From: Donna Trethewey [REDACTED]
Sent: 25 October 2021 11:40
To: Juan Baeza
Cc: [REDACTED]
Subject: A/26/21/RES

Further to the receipt of the amended site plan for planning application A/26/21/RES received from Oliver Neave, as shown below

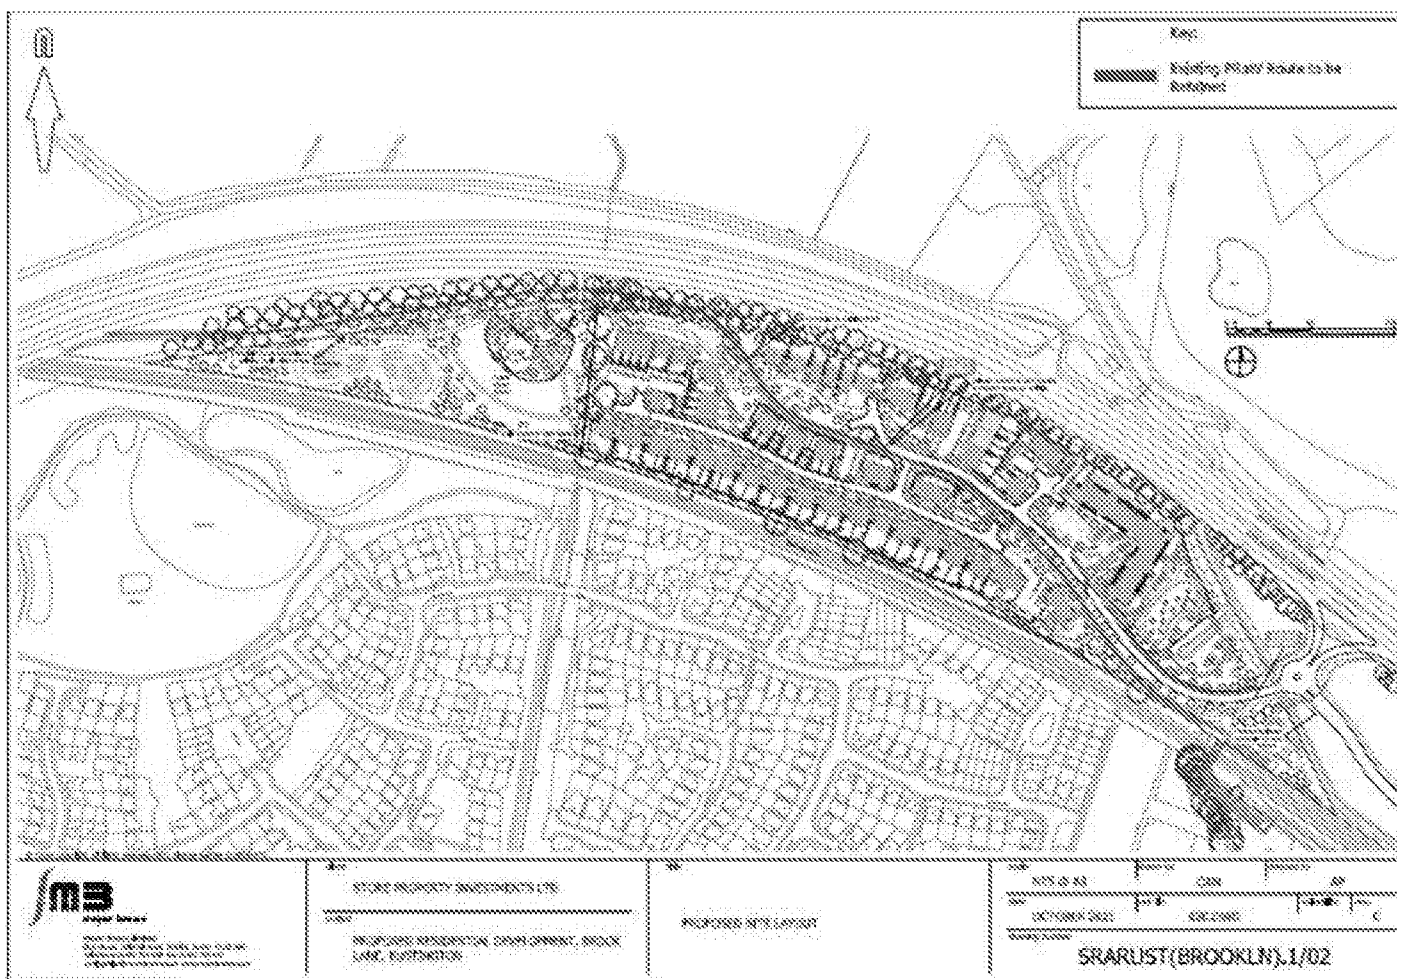
please note that I am happy that Public Right of Way, FP2159 will remain a footpath, separate to the road and internal cycle routes, with well-placed signs to cyclists to dismount where there are connections.

To the western end of the site, I welcome the cycle path running up to the site boundary allowing for possible connection at a future time, should it become possible to upgrade the footpath to a bridleway.

General comments regards surfacing, structures, drainage and the widths of both FP2159 and FP2160 from my first response still stand.
